# Review Report: Building C-400 Thermal Treatment 90% Remedial Design Report and Site Investigation, PGDP, Paducah Kentucky

15 August 2007

Dr. Brian Looney, Savannah River National Laboratory: Review Technical Lead

**Figure 4. MIP Boreholes and ECD response overlaying interpolation of PID responses in the Southeast Source Zone area (looking North).**

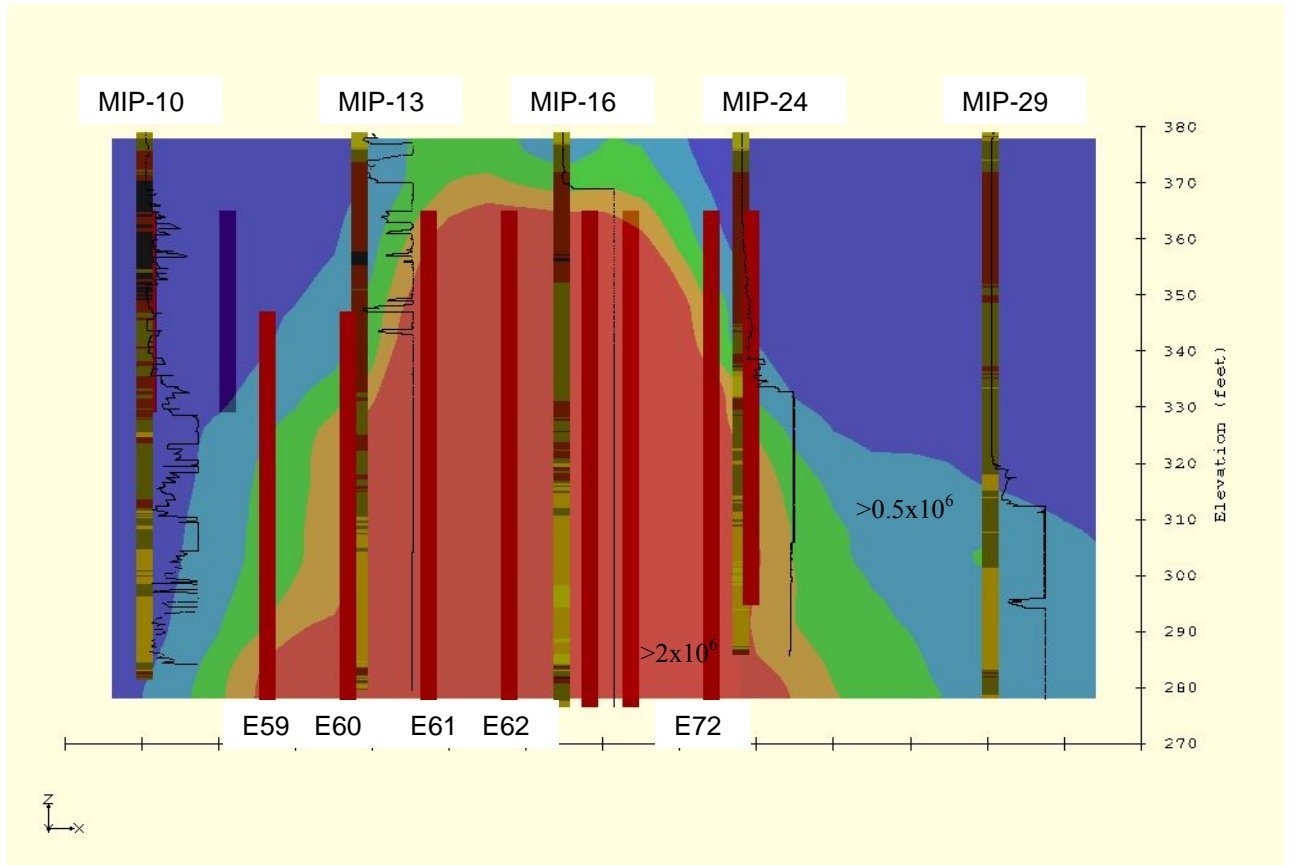
A key type of output from the effort is shown in Figure 4; this is a cross-section of the C-400 southeast source zone region where the color filled contours represent an interpolation of the MIP PID data. The red color represents responses greater than  $2 \times 10^6$  uV and the light blue are responses between 1 and  $0.5 \times 10^6$  uV. Overlaying the contours are MIP borehole logs where the black line associated with each MIP borehole is the discrete depth ECD responses in uV. Also shown are the proposed locations of ERH electrodes indicated as red columns.

Since no confirmation soil or groundwater samples were collected from the MIP boreholes, the PID responses associated with TCE DNAPL are unknown. However, there were two other detectors used to analyze the gas stream collected by the MIP including the FID and ECD. While the FID responses were similar to that of the PID (not shown), there appears to be a relationship between the interpolated PID values to the ECD responses as shown in Figure 4. For example, the PID response from MIP29 between 68 and 76.6 feet bgs (311 and

302 feet elevation) was greater than  $2 \times 10^6$  uV and the ECD detector was at the maximum response of  $1.3 \times 10^7$  uV in this region as well. The similarity between the maximum ECD and PID responses that suggested the presence of TCE DNAPL are also evident in the MIP13, MIP16, and MIP24 results. Note that the treatment volume targeted by the electrodes does not extend to the east to encompass the MIP29 location, where PID responses exceeded the  $9 \times 10^6$  uV PRS DNAPL threshold value near 75.7 feet bgs.

5.1.1 The ITR team determined that the target zone delineation should be modified based on data collected during system installation and based on key data from the 90%RDSI. Subsidiary and cross-linked recommendations are: 5.1.1a, 5.1.1b, 5.3.1, 5.3.4, and 5.3.5.

**Figure 5. MIP Boreholes and ECD response overlaying interpolation of PID responses in the Southeast Source Zone area (looking West).**

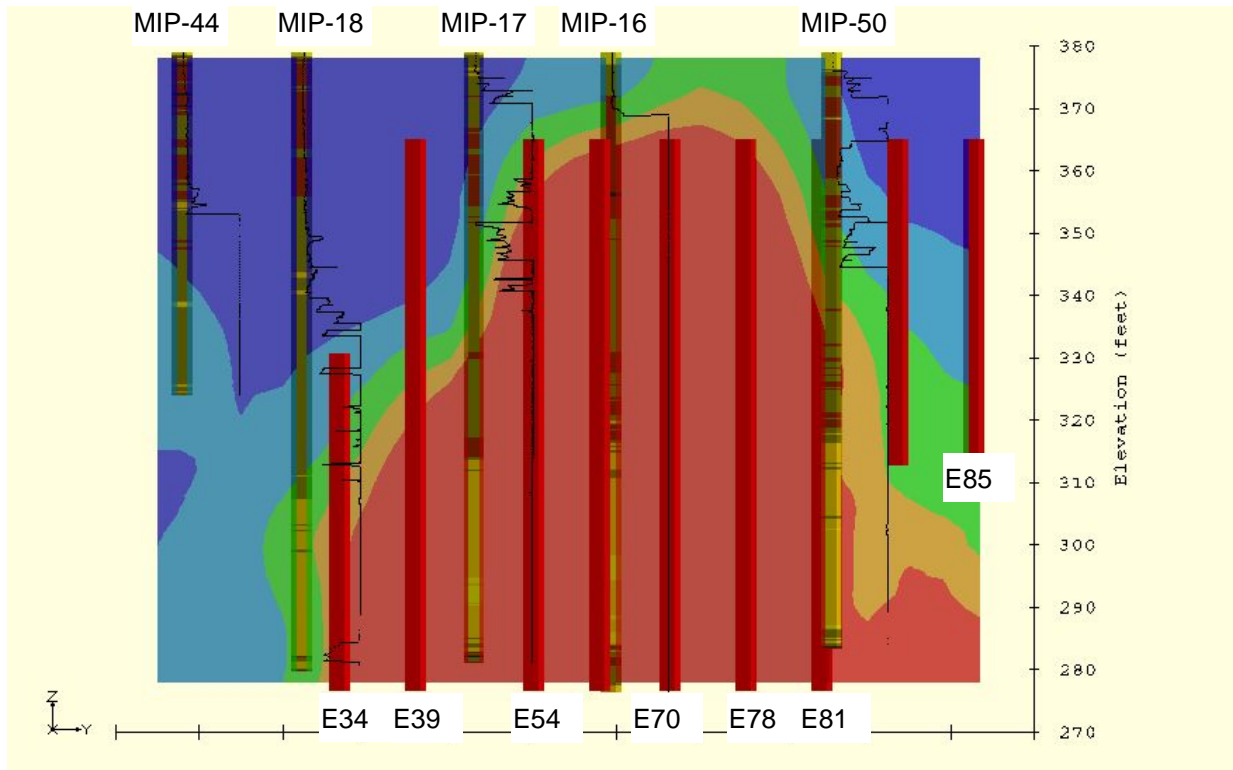
The southern and northern limits of the Southeast thermal treatment zone are worthy of additional examination. Figure 5 shows ECD responses and PID interpolations indicating the possible presence of DNAPL to the south of MIP18. However, since MIP44 only extended to 55 feet bgs, there are insufficient data to support the assumption that MIP18 defined the southern-most limit of neat TCE. North of MIP50, the treatment volume extends to 66.3 feet bgs even though TCE DNAPL may be present at depths down to 104 feet bgs based on the PID interpolations and the ECD response from MIP50.

**Figure 6. MIP Boreholes and ECD response overlaying interpolation of PID responses in the Southwest Source Zone area (looking North).**

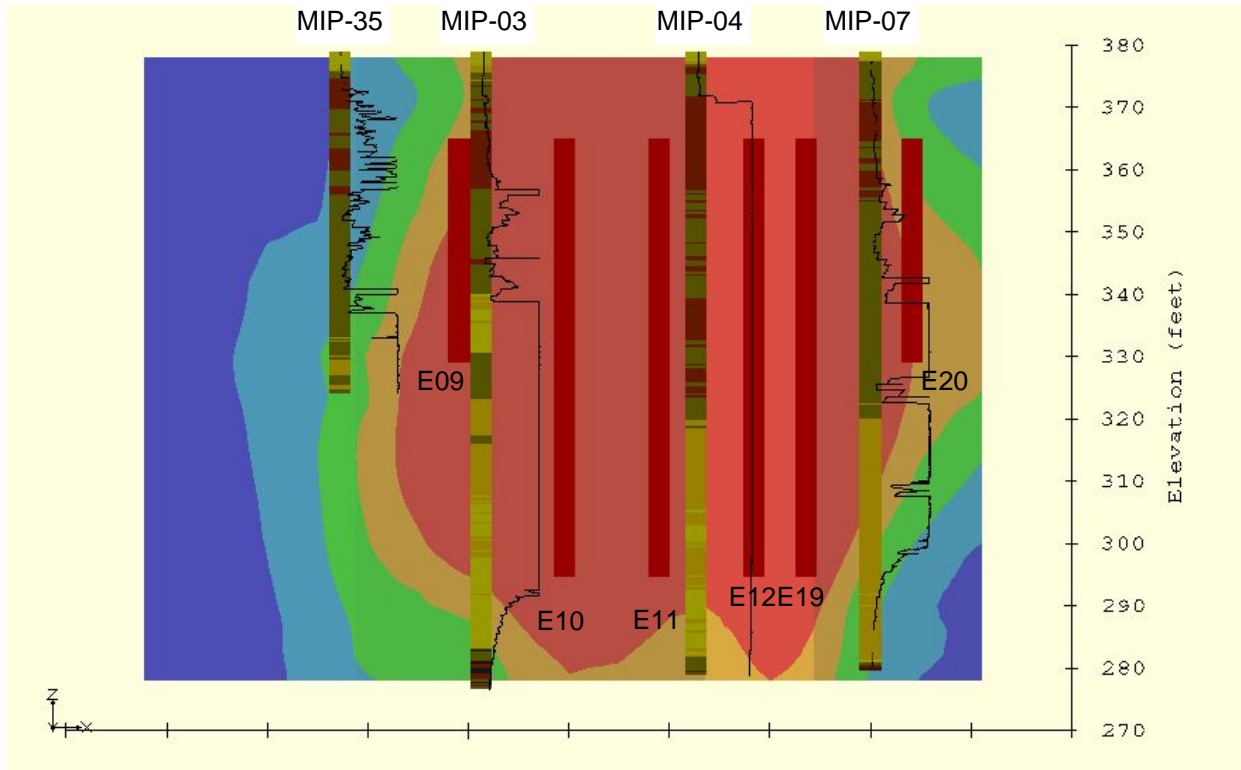
Similarly, in the Southwest source zone area (Figure 6), the thermal treatment volume does not extend to the lower permeability soil found at approximately 100 feet bgs. The PID responses were greater than  $0.5 \times 10^6$  uV at 100 feet bgs and the ECD was at the maximum value in MIP04, therefore, TCE source may be present at this depth.

**Figure 7. MIP Boreholes and ECD response overlaying interpolation of PID responses in the East Southeast Source Zone area (looking North).**

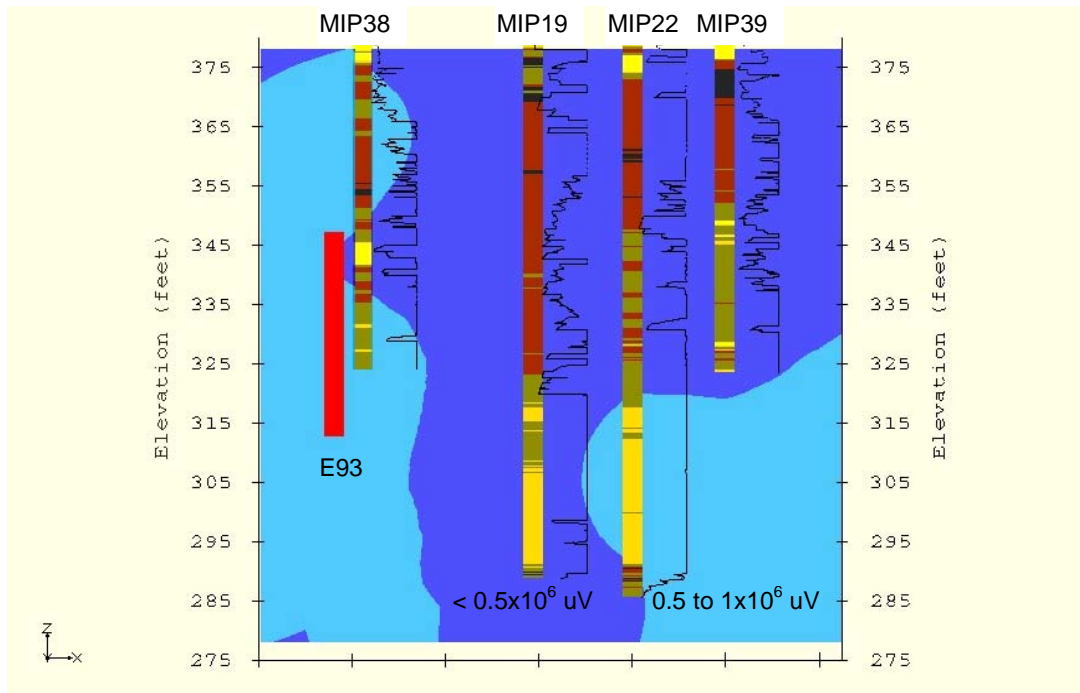
Another area of interest is near 400-046 on the east side of the building, where groundwater concentrations of TCE in excess of 100 mg/L were found during the WAG6 investigation. While the ECD was at its maximum response value in all four MIP boreholes shown in Figure 7, the PID values for MIP19 never exceeded  $0.7 \times 10^6$  uV. However, there were two depths for MIP22 where PID readings exceeded  $1 \times 10^6$  uV including between 61 and 65, and 77 and 78 feet bgs. This area should be sampled during system installation and treated if necessary.

Figure 8. Monitoring Wells in the vicinity of the C-400 Building at PGDP

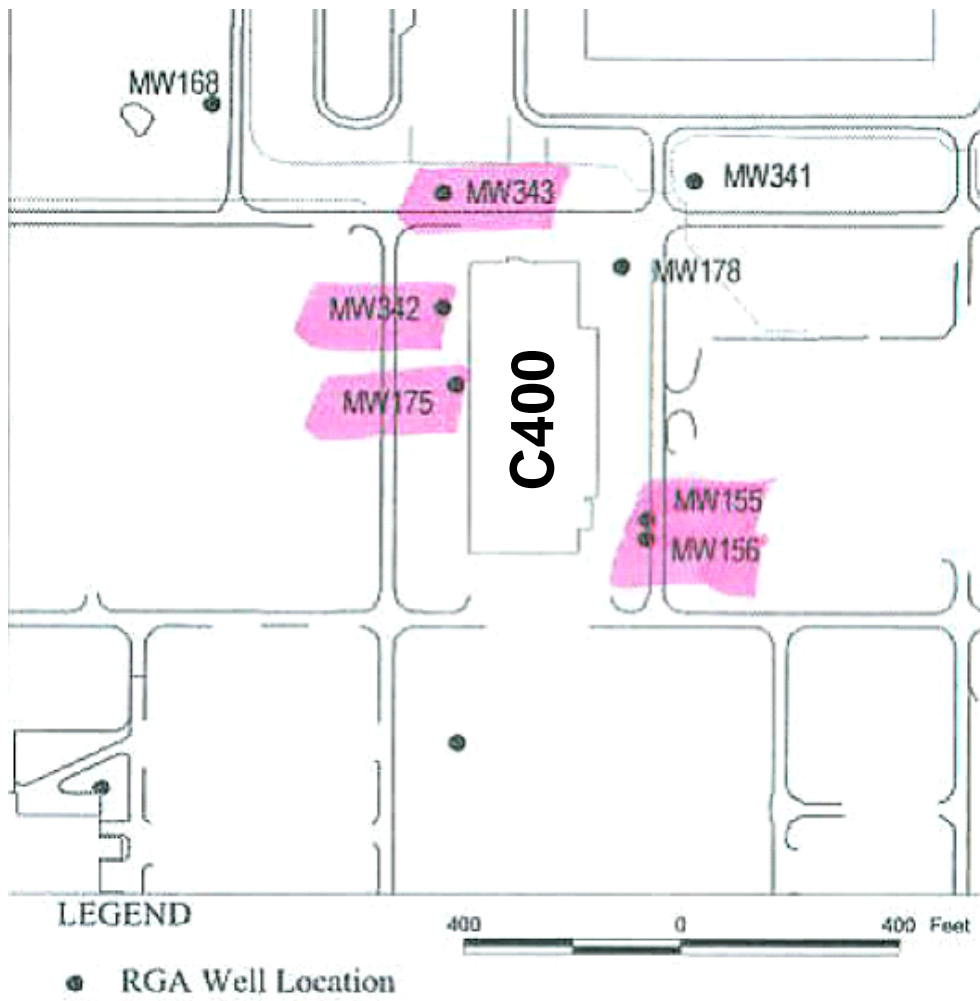
The C-400 area has only a few groundwater monitoring wells with limited screen intervals (Figure 8). Although depth-discrete soil samples and the MIP have been useful for characterizing the source area, monitoring wells as indicators of the overall ground water contamination in the area are usually the ultimate regulatory criteria for cleanup. MW 155 (screened in the lower RGA) and MW156 (screened in the upper RGA) appear to be the only monitoring wells in the principal source area on the southeast side of the C-400 building. Wells MW175 (screened in the middle RGA), MW342 (also screened in the middle RGA), and MW343 (screened in the lower RGA) on the northwest side of the building are downgradient wells from the main source.

Because these listed wells are widely spaced and may not have comparable screen zones, their data will have limited utility to adequately evaluate groundwater response in the C-400 source area. Nevertheless, there are interesting historical concentration trends through time for these wells which suggest these types of data may be useful (graphs of these trends are provided in Appendix C). Two of the trends observed include a decrease in TCE concentration from initial monitoring in the upper and middle RGA wells and relatively constant or increasing concentrations in the lower RGA. Three of the monitoring wells (MW343, MW155, and MW156) show a distinct change in concentrations following the ERH pilot test conducted in February through September 2003. TCE concentrations in MW156 (upper RGA) dropped from values greater than 150 mg/l to less than 50 mg/l following the pilot test. TCE concentrations in MW155 (lower RGA) rose from approximately 2 mg/l to 8 mg/l. While TCE concentrations in MW343 (lower RGA, down gradient) moved from an average of approximately 80 mg/l to an average of 70 mg/l. Wells MW175 and MW342 do not seem to be significantly affected by the pilot test.

Additional groundwater monitoring wells will be required to determine the impact of thermal treatment on the amount of TCE mass being released to the RGA.

5.1.2 Install additional ground water monitoring wells (multiple depths and locations) to provide the basis for assessing the broader impacts of the Building C-400 remediation on the overall PGDP groundwater plume(s). Consider monitoring well clusters closer to the C-400 building on both the east side and northwest corner and multiple screened intervals (at least two screen intervals in the RGA and a screen in the UCRS). Cross-linked recommendations are: 5.2.2b, and 5.2.2c.

**Figure 9. Idealized heating profile for a simple saturated system containing TCE DNAPL and water**

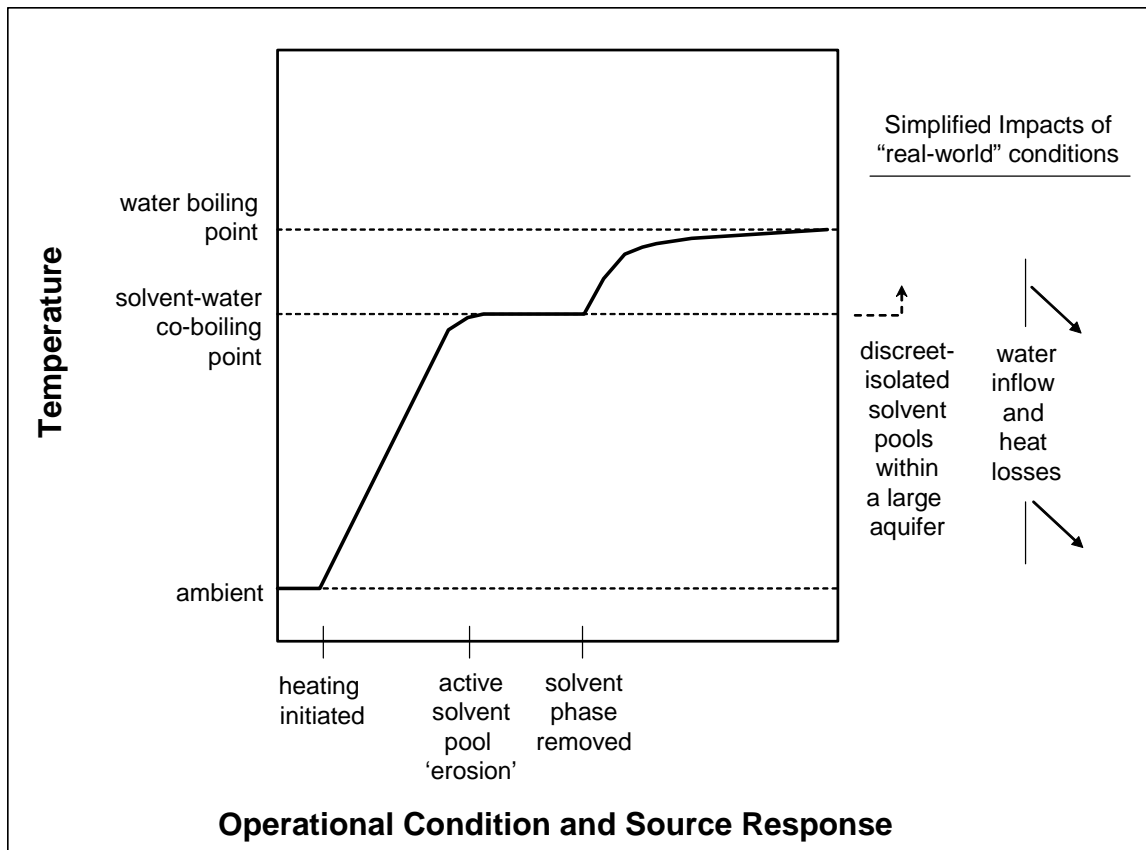
5.2.1 Issue: The proposed ERH temperature monitoring targets need to be revised based on thermodynamic considerations. For example, the proposed criterion below the water table is the co-boiling point of a saturated TCE solution, however, heating to this temperature is not a robust indicator that the TCE DNAPL has been removed.

Thus, temperatures in the subsurface that stabilize near the co-boiling temperature should be taken as an indication that TCE DNAPL is still present; while effective TCE DNAPL removal requires achieving temperatures above the co-boiling point. Note that real-world conditions factor in as well (see modifying factors in Figure 9). In permeable environments, such as within the RGA, additional energy is needed to compensate for the cooling impacts of flowing groundwater and other heat losses. Importantly, the DNAPL pools and ganglia are likely to be isolated within a relatively large volume of aquifer, and the bulk system will actually “stabilize” at a temperature higher than the co-boiling point (it is only in the immediate vicinity of substantive TCE DNAPL pools that the temperature is thermodynamically controlled and the large areas of aquifer in between will heat past the co-boiling point).

5.2.1 The temperature target above the water table should be based on exceeding the boiling point of the TCE DNAPL. The temperature target below the water table should be set between the co-boiling point of a TCE-water mixture and the boiling point of water (at the nominal local pressure conditions). The final target temperatures should be based on site-specific modeling. Throughout the saturated target zone, the target temperature should be set as close to the boiling point of water as is realistic and achievable, and the temperature monitoring system should be set up to sample in a representative manner and to assure that all areas of known DNAPL are effectively heated. Cross-linked recommendations are: 5.2.2, 5.2.3, 5.2.5, 5.3.3, and 5.3.7.

Figure 10. Simplified schematic of convection processes during ERH of the permeable portion of the treatment zone

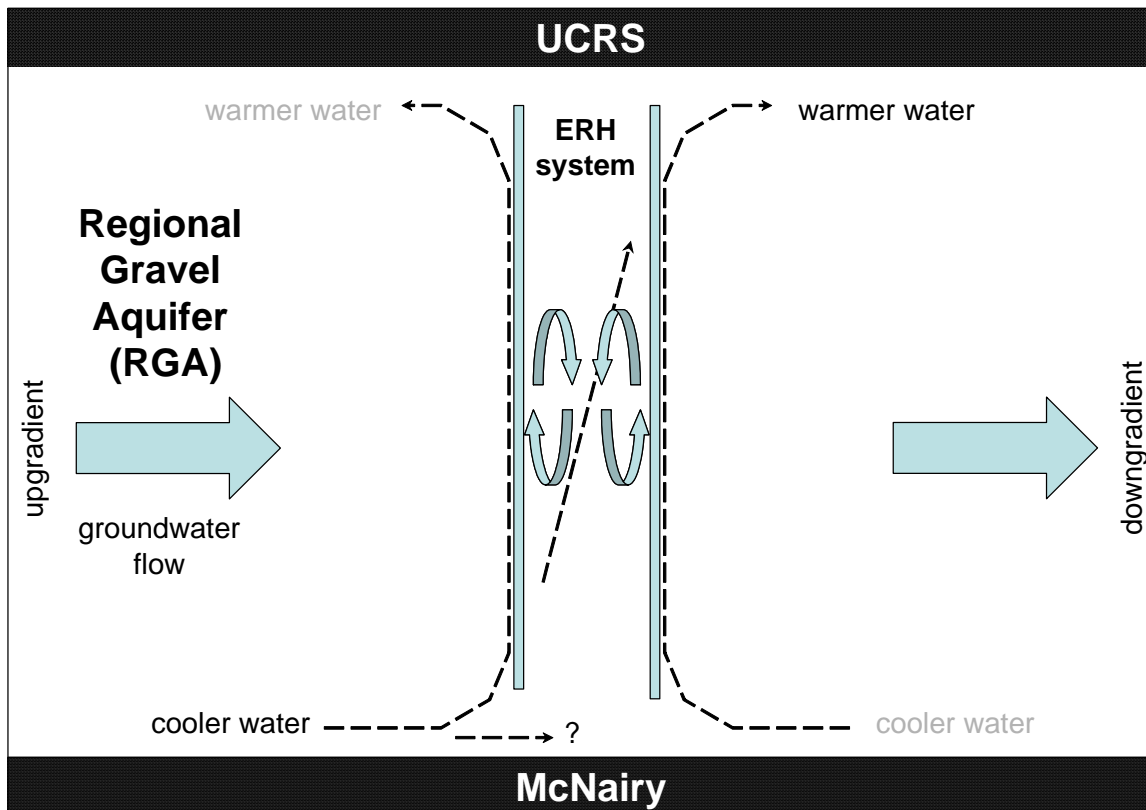
Uncertainties remain, particularly in the ability to heat all portions of the RGA including the deepest interval in the Southeast target zone and in linking the heating to the amount/effectiveness of contaminant removal. The ERH pilot test performed at this site, for example, did not fully heat the entire thickness of the RGA and the deepest portions of the section were the most difficult to heat efficiently. While reasonable and prudent steps were implemented in the 90% RDR to address lessons learned from the pilot test, the primary uncertainty is unresolved. The question remains: will the full scale application of ERH in

the highly permeable RGA provide adequate energy to reach the desired temperatures? One under-considered factor related to the difficulty in heating the deepest interval of the RGA is large scale convection (Figure 10). Note that this process would tend to pull cooler water into the treatment zone at the bottom and discharge warm water from the upper part of the treatment zone (with some internal cycling occurring within the zone). This particular process is sensitive to boundary conditions in design modeling and the impacts might be exacerbated by the presence of heterogeneities (e.g., a high permeability layer near the top of the RGA).

5.3.1 The risk of full scale implementation should be mitigated by phasing or by assuring acceptable operational responsiveness and flexibility. Cross-linked recommendations are: 5.2.3, 5.3.1, 5.3.5, and 5.3.9.

**Figure 11. Estimated Shape of the Steam Injection Front in the RGA**

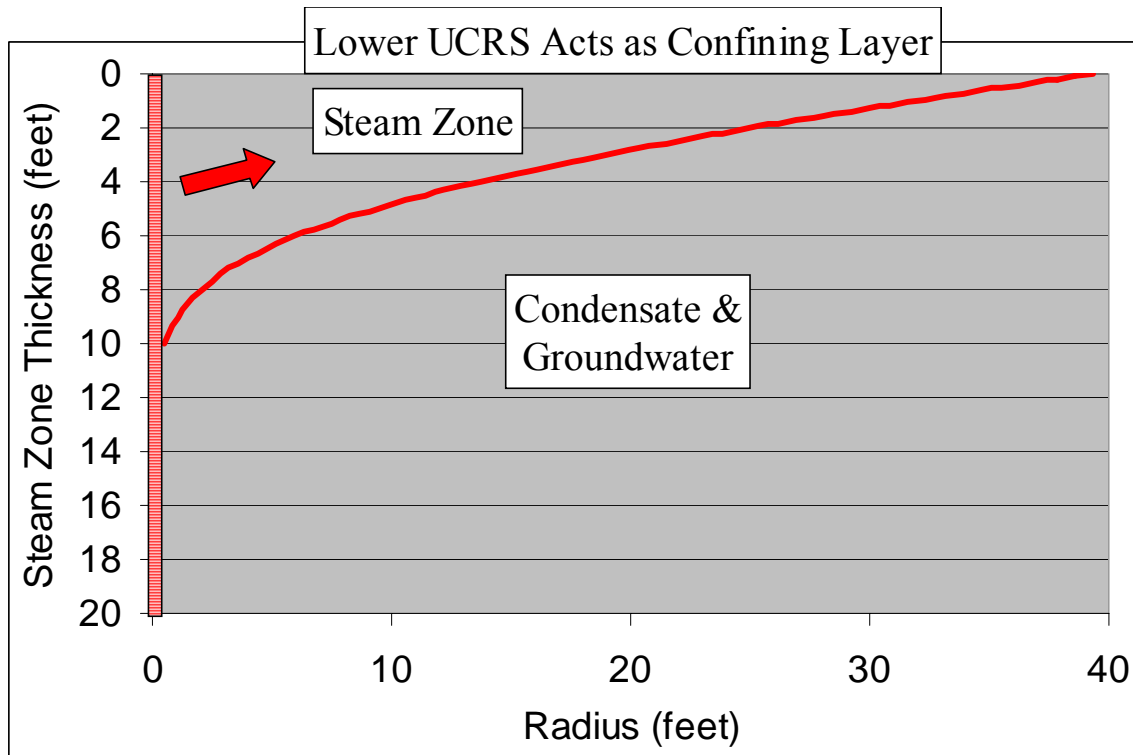
The shape of the steam front resulting from injection of steam into the RGA at the design rate of about 2,000 pounds per hour was estimated utilizing the model of van Lookeren (1983). The result of the calculation is illustrated in Figure 11. The steam zone exists around the injection well only above the red line and liquids exist below. This plot suggests that the bottom of the RGA will not be significantly heated by steam injection. Any DNAPL in this region will not be displaced and recovered. Further, attempts to mitigate this effect by screening deep in the RGA would not be successful as buoyancy and the path of least resistance would bring the steam zone to the top of the RGA before lateral growth could be achieved deep in the RGA.

The re-contamination of the former ERH pilot test area has not been verified by field data to adequately justify the need to re-treat this soil volume with an additional technology. Further, the ITR team believes that the majority of the “shot” emplaced in boreholes for the pilot electrodes would have remained in the boreholes and thus is amenable to removal by overdrilling. This suggests that ERH coverage might be cost effectively added to the primary ERH system if treatment is needed for this area.

5.3.2a If the steam injection is eliminated the ITR team believes that the remediation objective for that target area could be achieved using the primary ERH system (through expansion of the electrode grid and removal of the former electrodes by overdrilling if necessary).

5.3.2b If the steam injection well remains in the system, extraction wells for hydraulic and pneumatic control must be included around the entire injection well to avoid a redistribution of contaminants to outside of the treatment area.
